HISTORIC LANDMARK COMMISSION
STAFF REPORT

Petition PLNHLC2008-00174 (470-08-16)
New Construction
539 East 900 South, Central City Historic District
September 3, 2008

The applicant requests the Historic Landmark Commission approve New Construction of a single-family home at approximately 539 East 900 South, a corner lot, in the Central City Historic District.

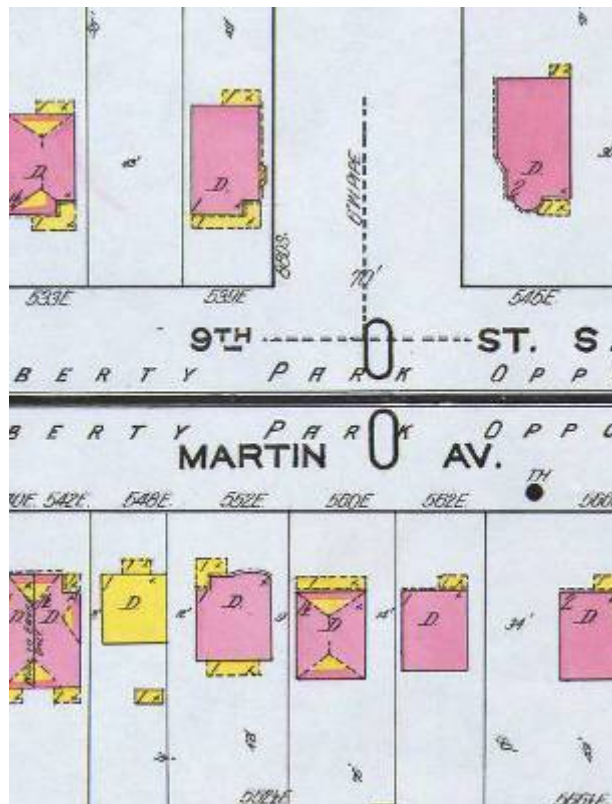
Discussion: The existing driveway will be improved and widened.

Finding: Staff recommends that the new driveway incorporate a drive strip.

A LEFT ELEVATION
1/4" = 1'-0"

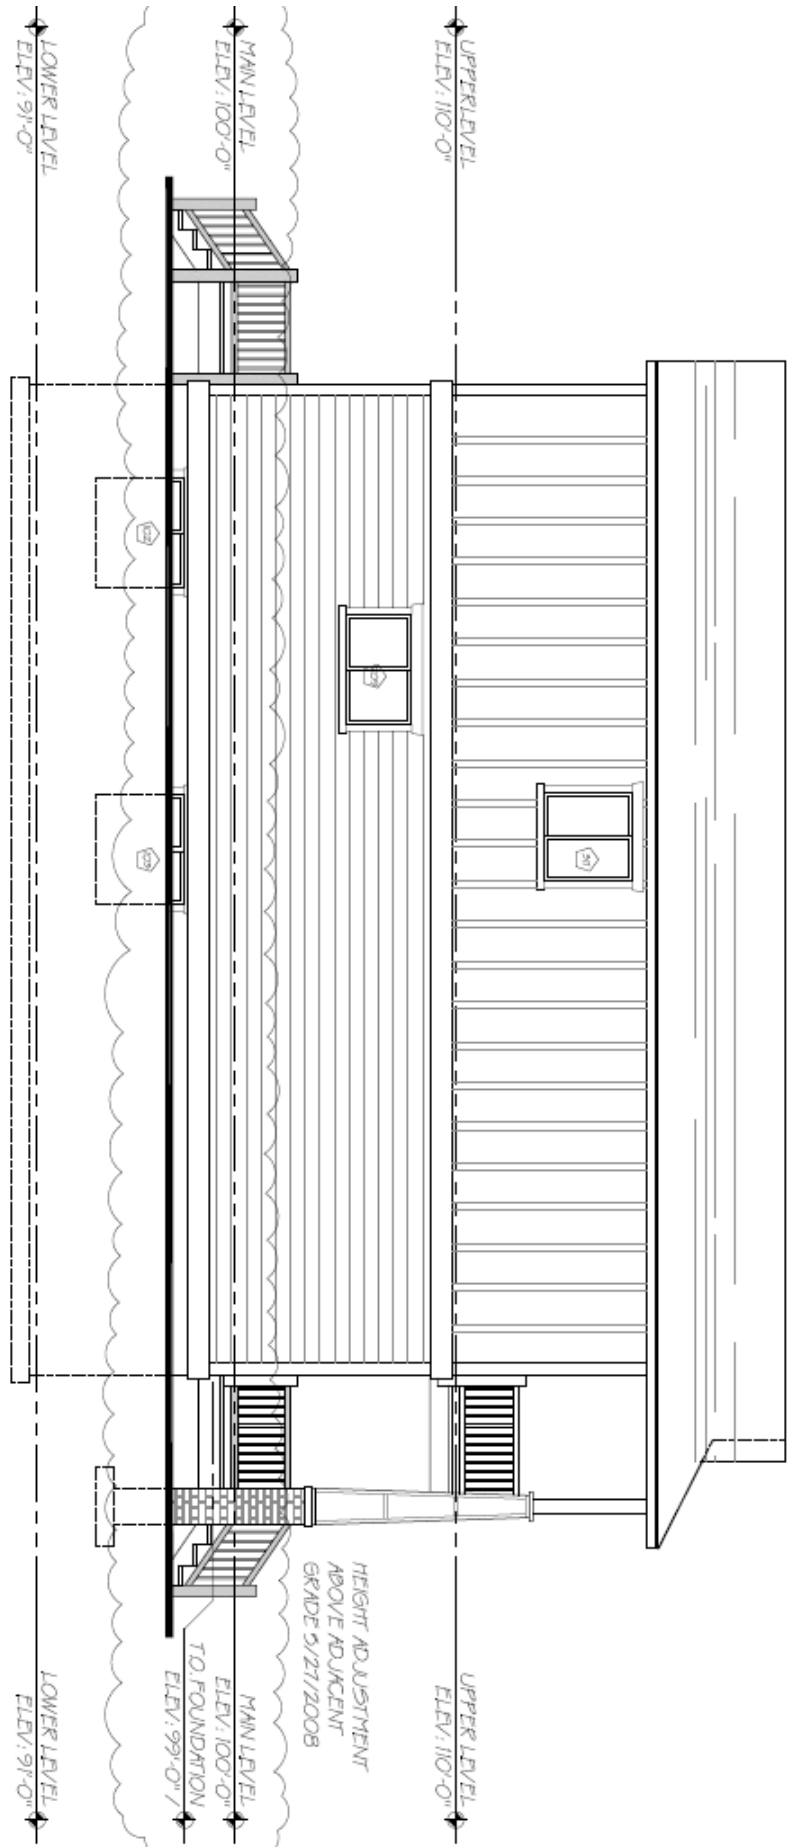
Finding: The historic ratio described is present in many of the windows of the proposed design but is not followed for the east and west elevations. Also the solid-to-void ratio of the proposed design is typical of the ratio seen on historic buildings in the district with the exception of the east and west elevations, which have few windows. The window depth of one inch (1") does not provide the depth and shadow lines seen on historic windows. The downstairs windows on the east elevation are close to the street, so the desire to not have many openings and to not have large openings is understood. In addition, the middle window is above the kitchen sink and two of the upper story windows are small to allow room for a bed. Slider windows are not typically seen on historic houses but are appropriate for new construction if the ratio is adequate and they are used on secondary elevations, as seen on the proposed design. **Staff recommends that only two of the upper story windows of the east elevation be enlarged so that they are at least twice as tall as they are wide. The smaller windows left on the upper floor of the east side will then read similar to the small windows to either side of a chimney. Further, staff recommends additional windows on the west elevation and that all windows have a greater depth from the wall of the building.**

A RIGHT ELEVATION
 1/5/10

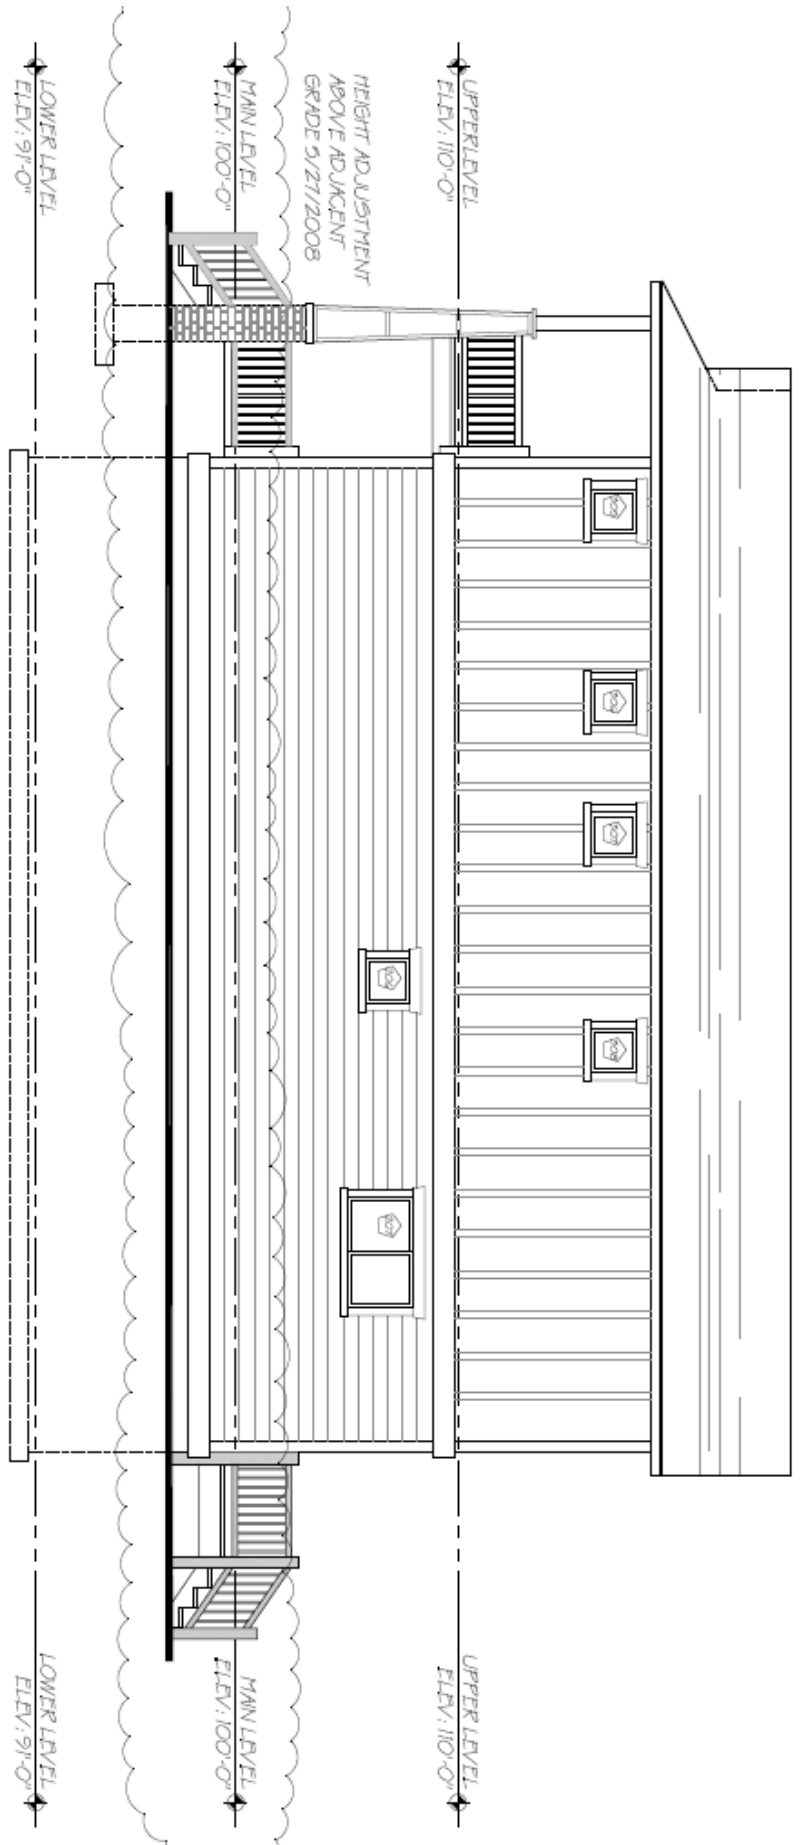
1. Two of the second story windows on the east elevation be altered so that they are twice as tall as they are wide;
2. Additional windows be added to side elevations;
3. Depth of windows from the wall face be increased;
4. The drive way include a drive strip;
5. The second story siding material be changed to another more appropriate material;
6. The second story porch roof be altered to extend the gable or have no porch roof; and
7. A date stone be added to any location where it does not interfere with the design of the building or appear to be an address.
